| Project/Equipment   |  | ADC/DAC MEZZANINE   |                   |
|   |  | File                | ADC_Buffer.SchDoc |
| Warsaw Univeristy of Technology                           |  | ISE                 | ARTIQ             |

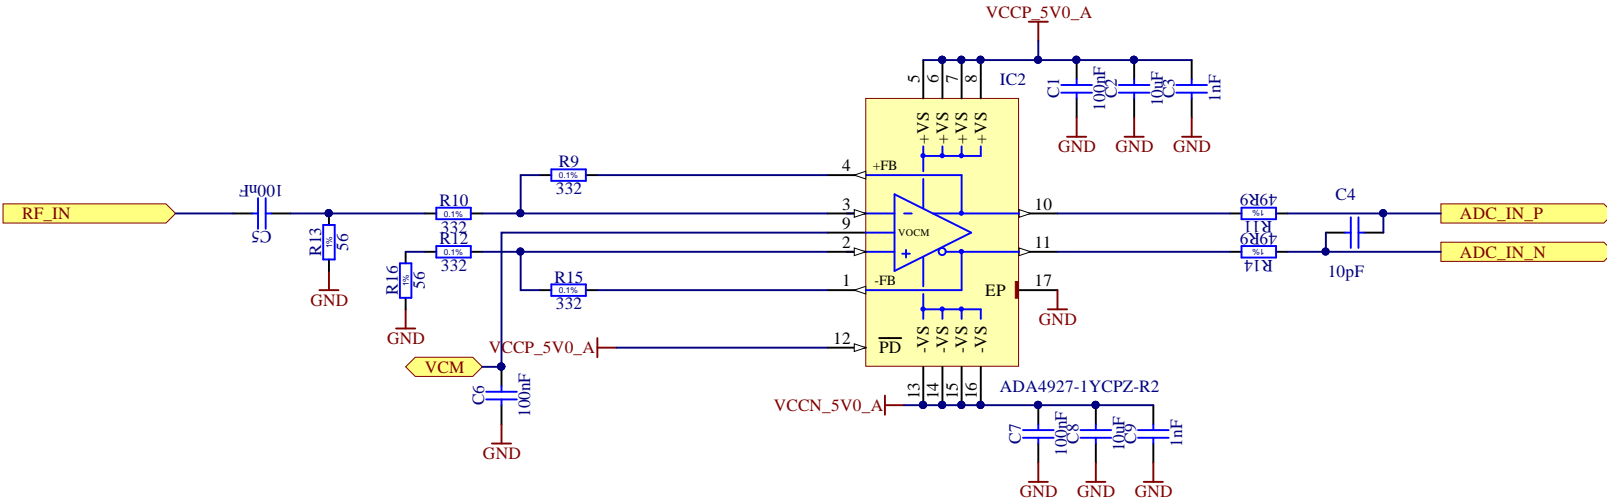
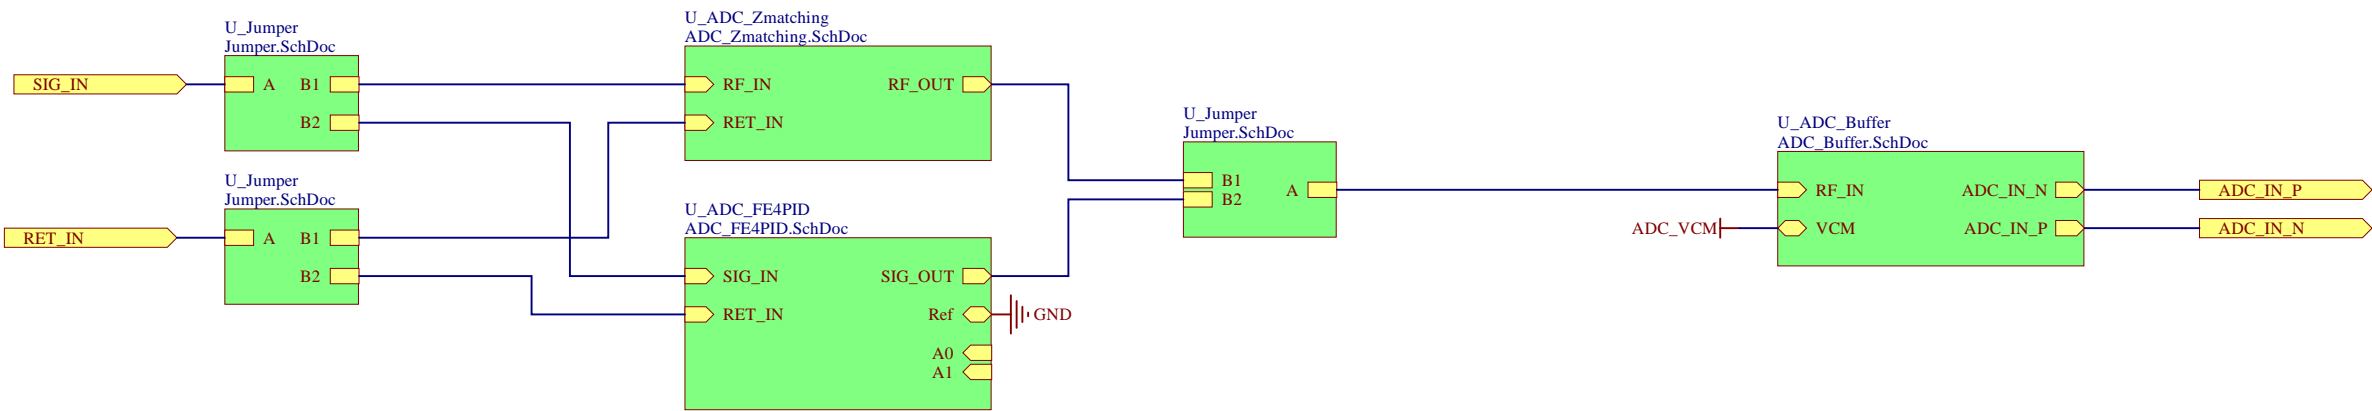
values to be reviewed, taken from AFE\_Mezz

|   | File       |                   | ADC_channel.SchDoc  |

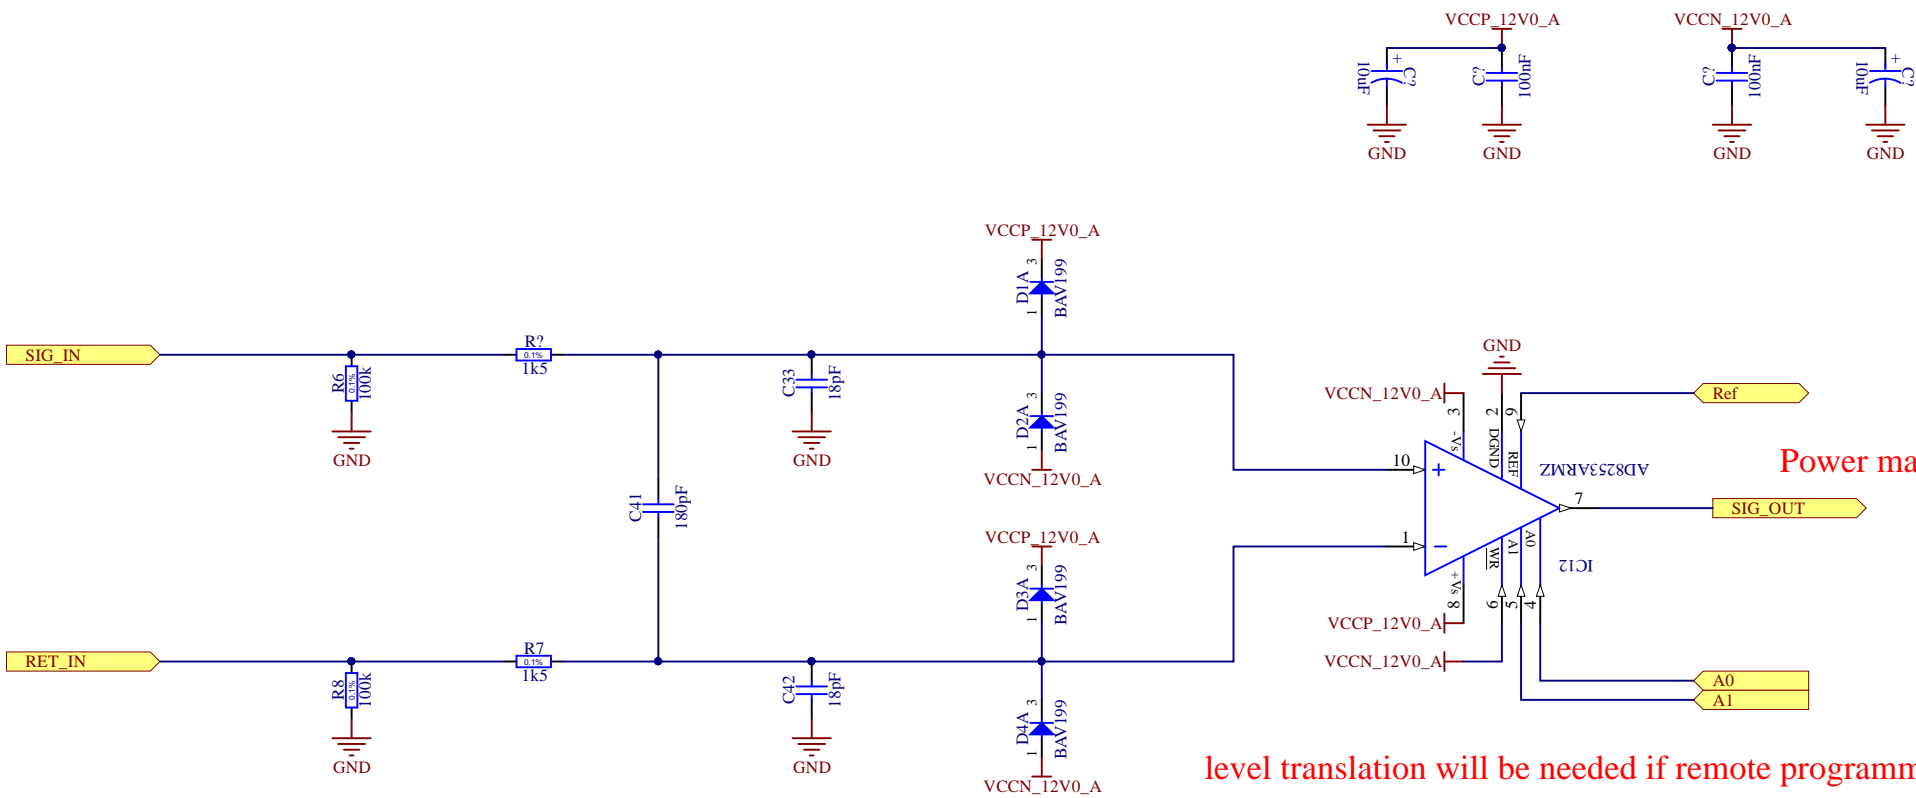
Add A0,A1 to comm. interface if required

|   |  |                                | File ADC_FE4PID.SchDoc |

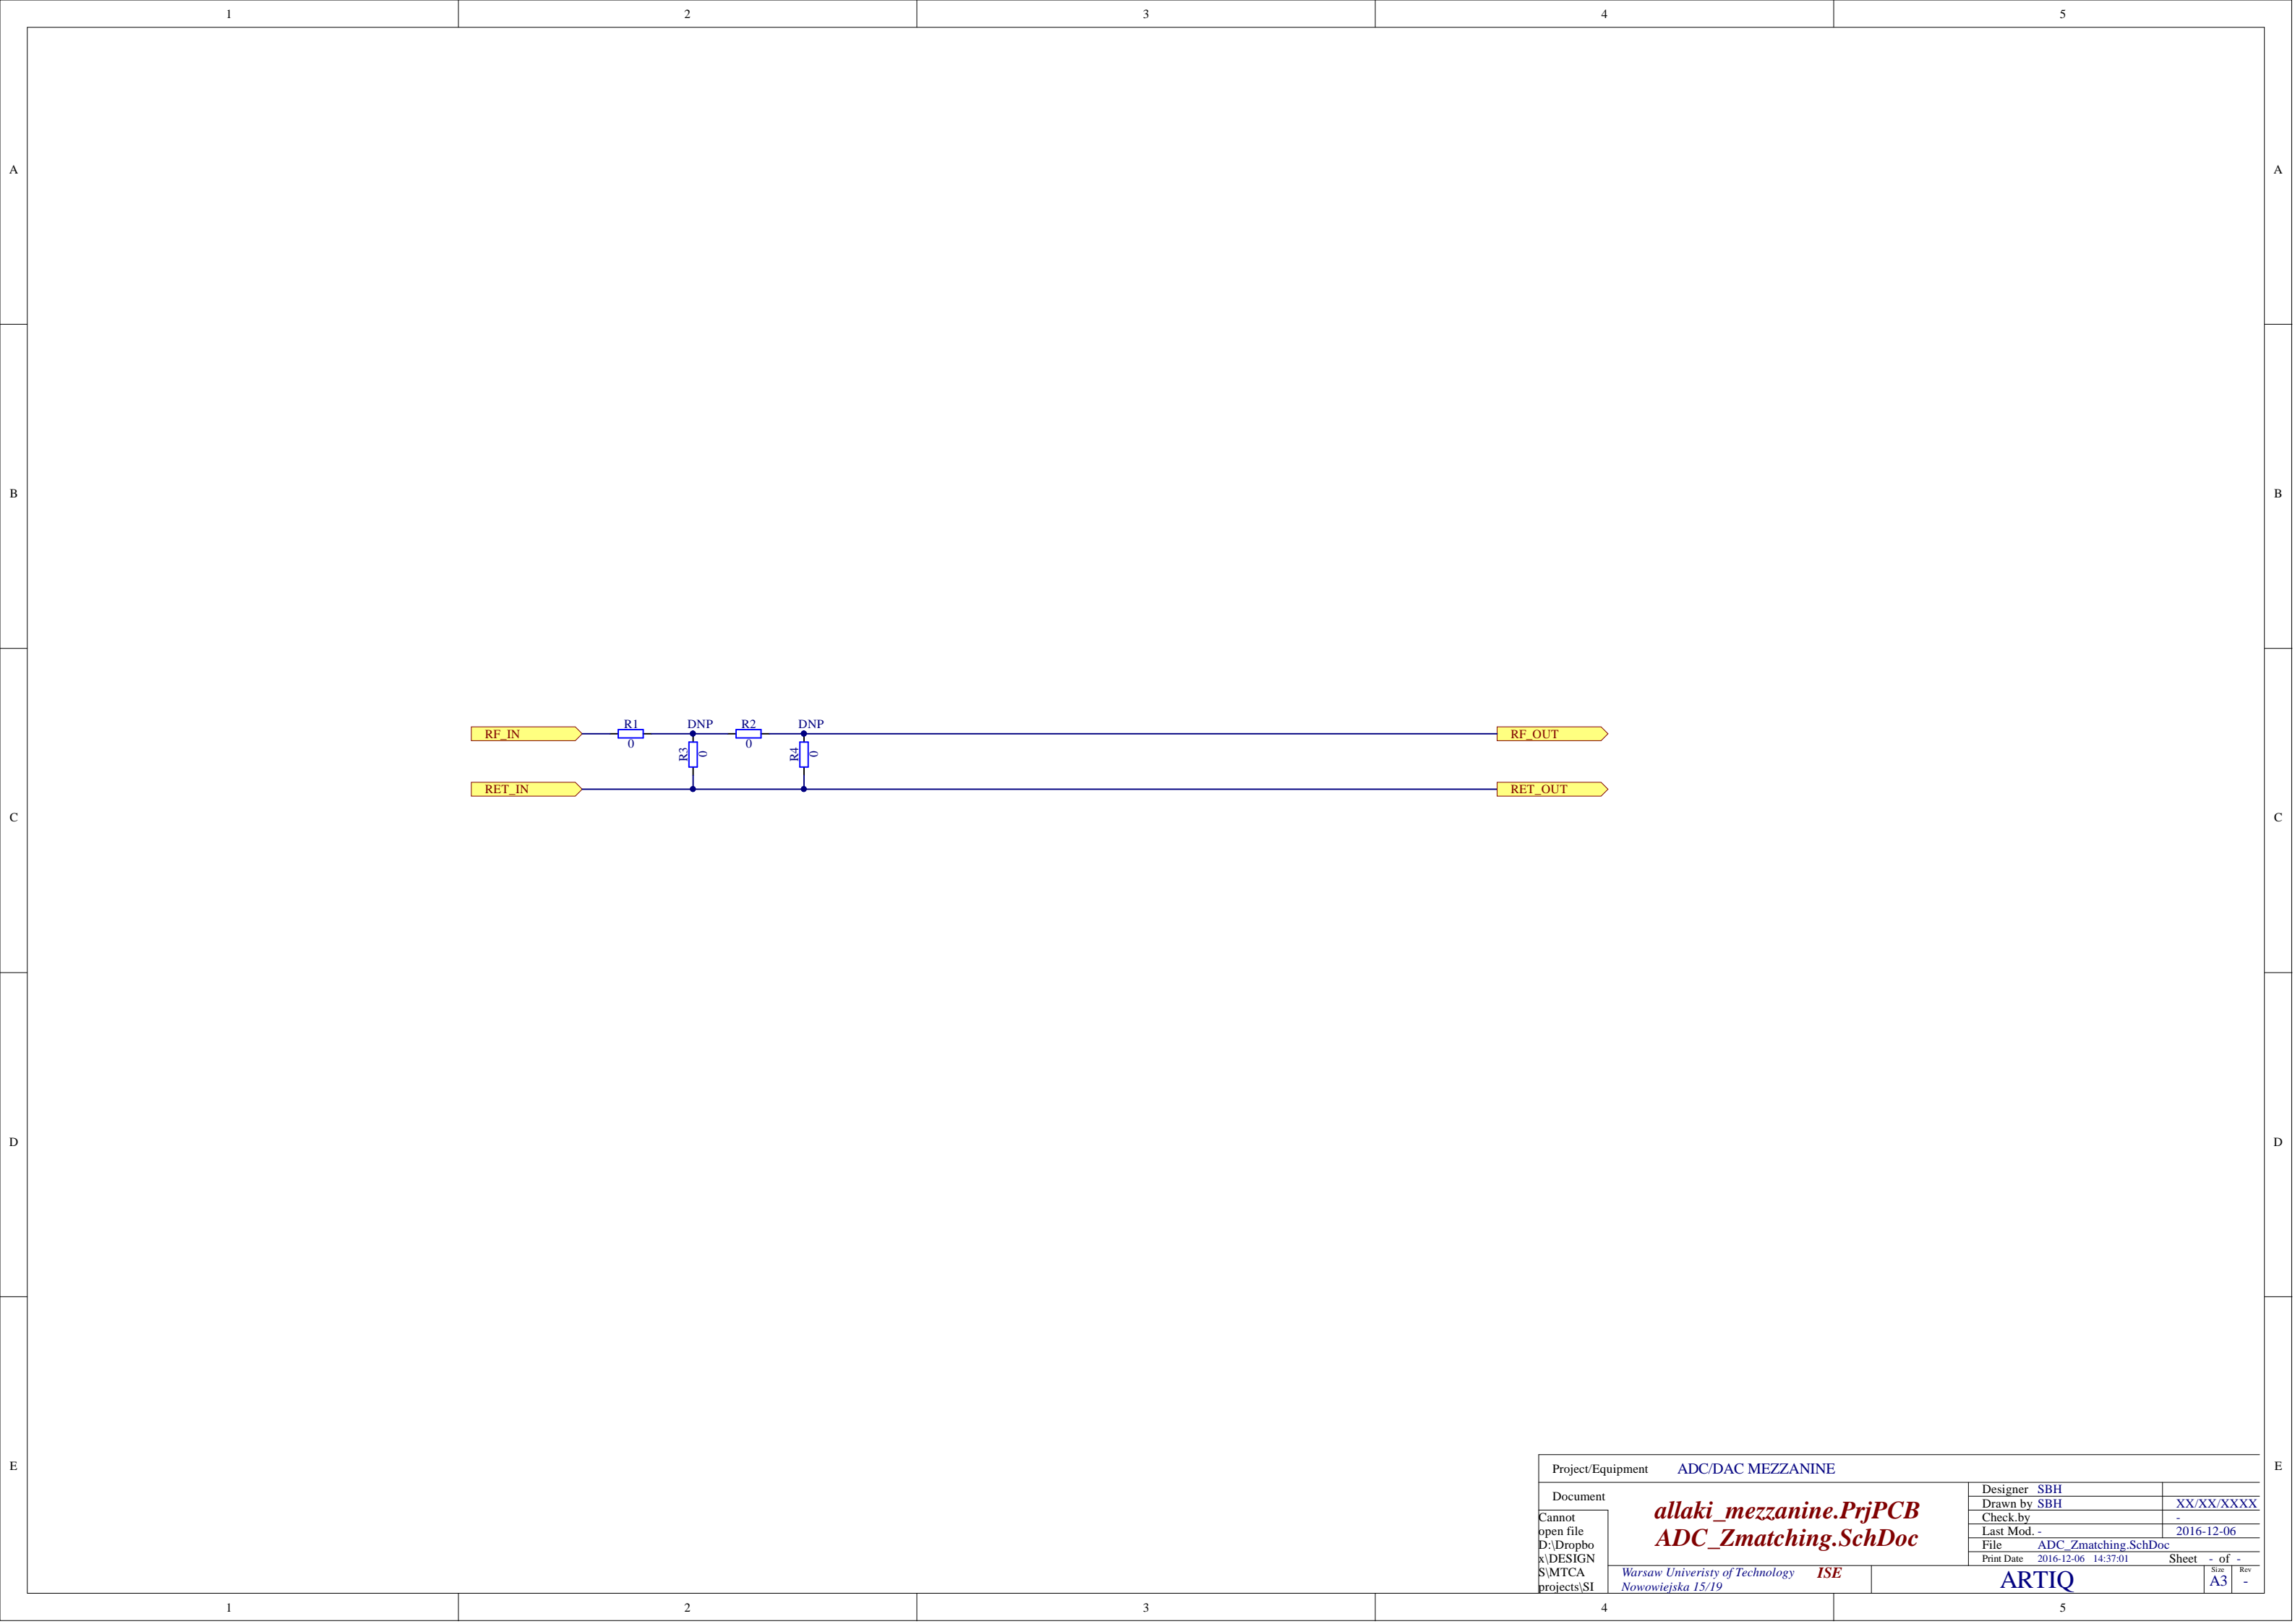
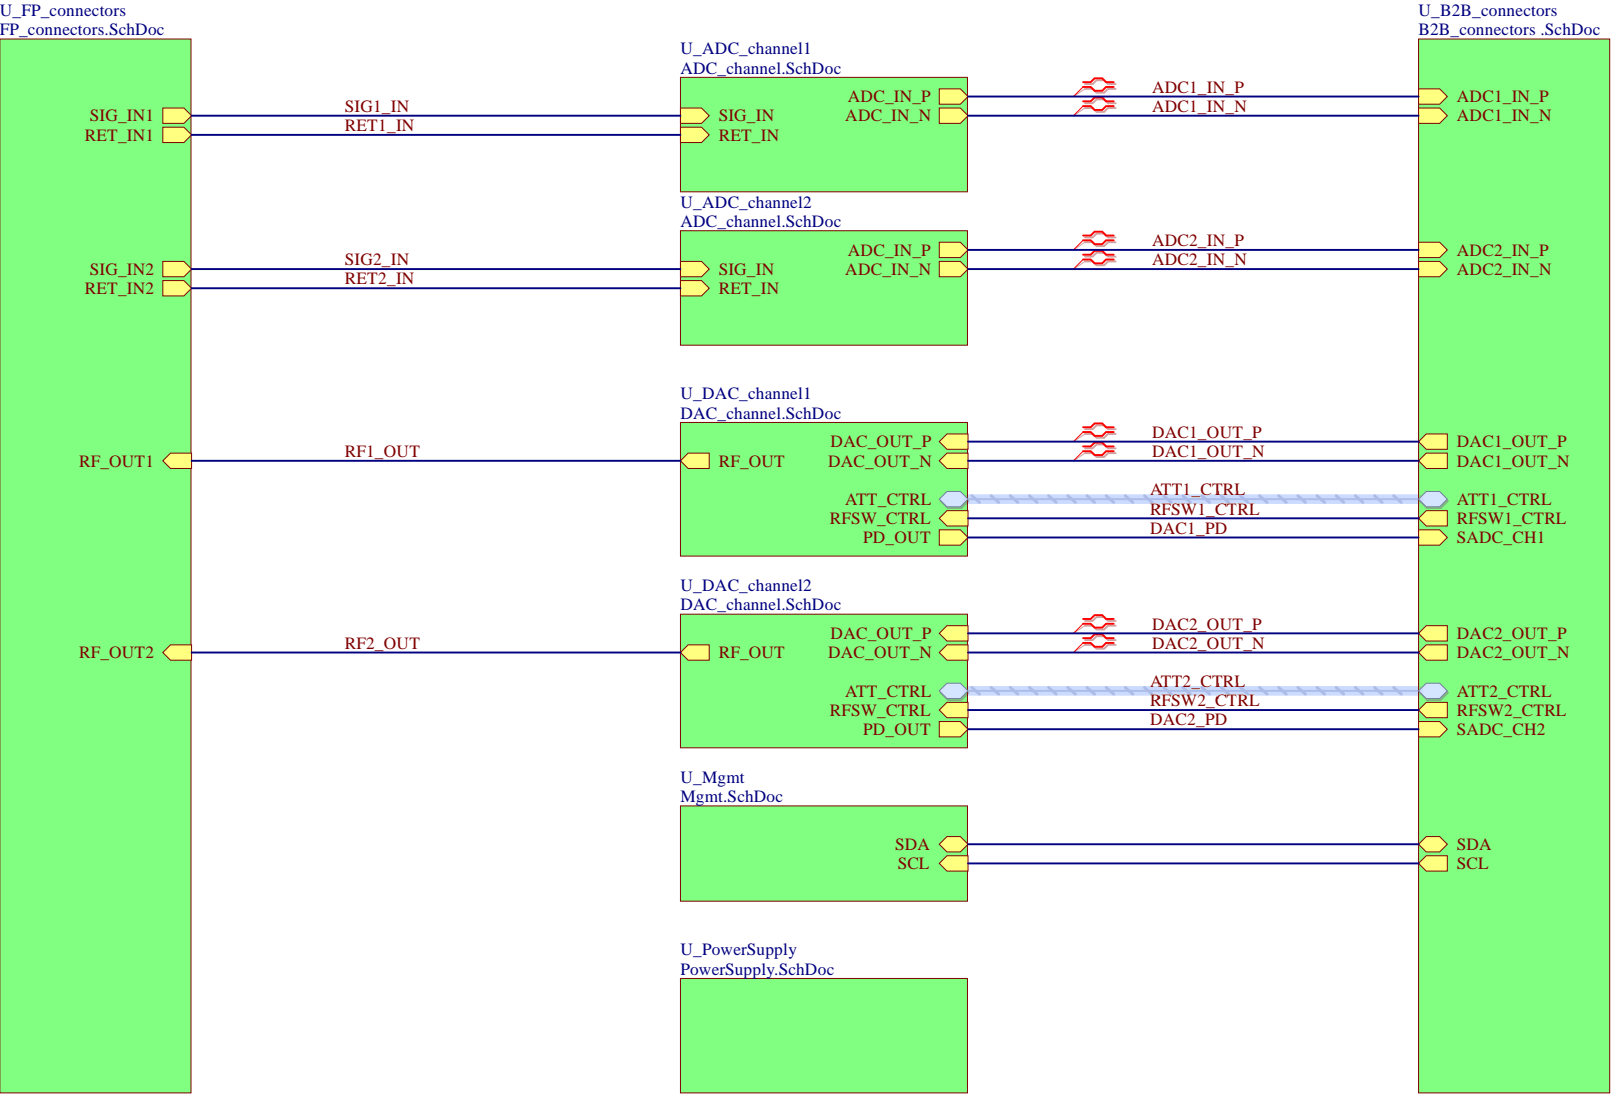
level translation will be needed if remote programming is required/possible switch

Power matching required

|   | File                            |                   | PowerDetector.SchDoc |  |

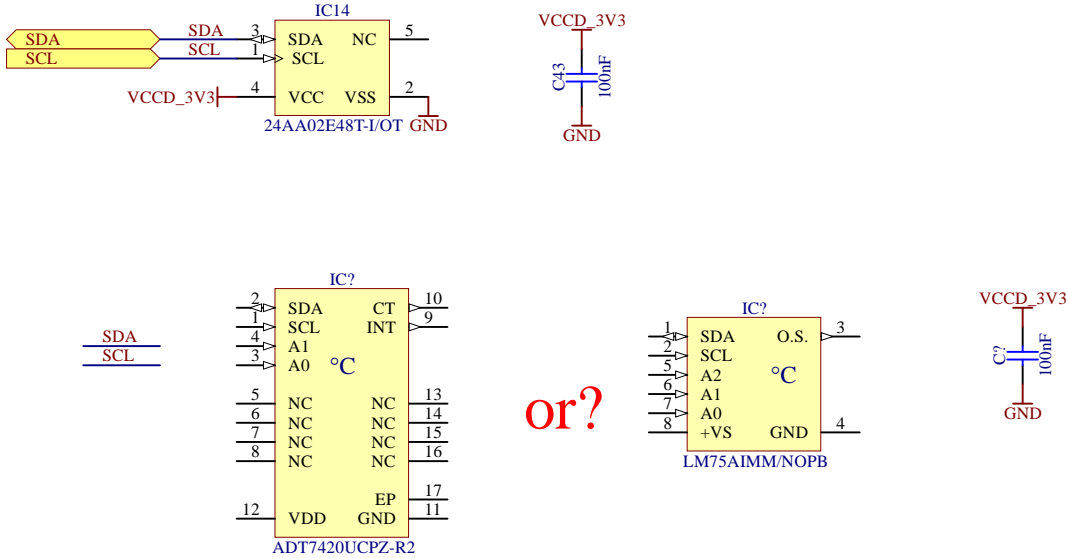
Temperature measurement

Ad8363
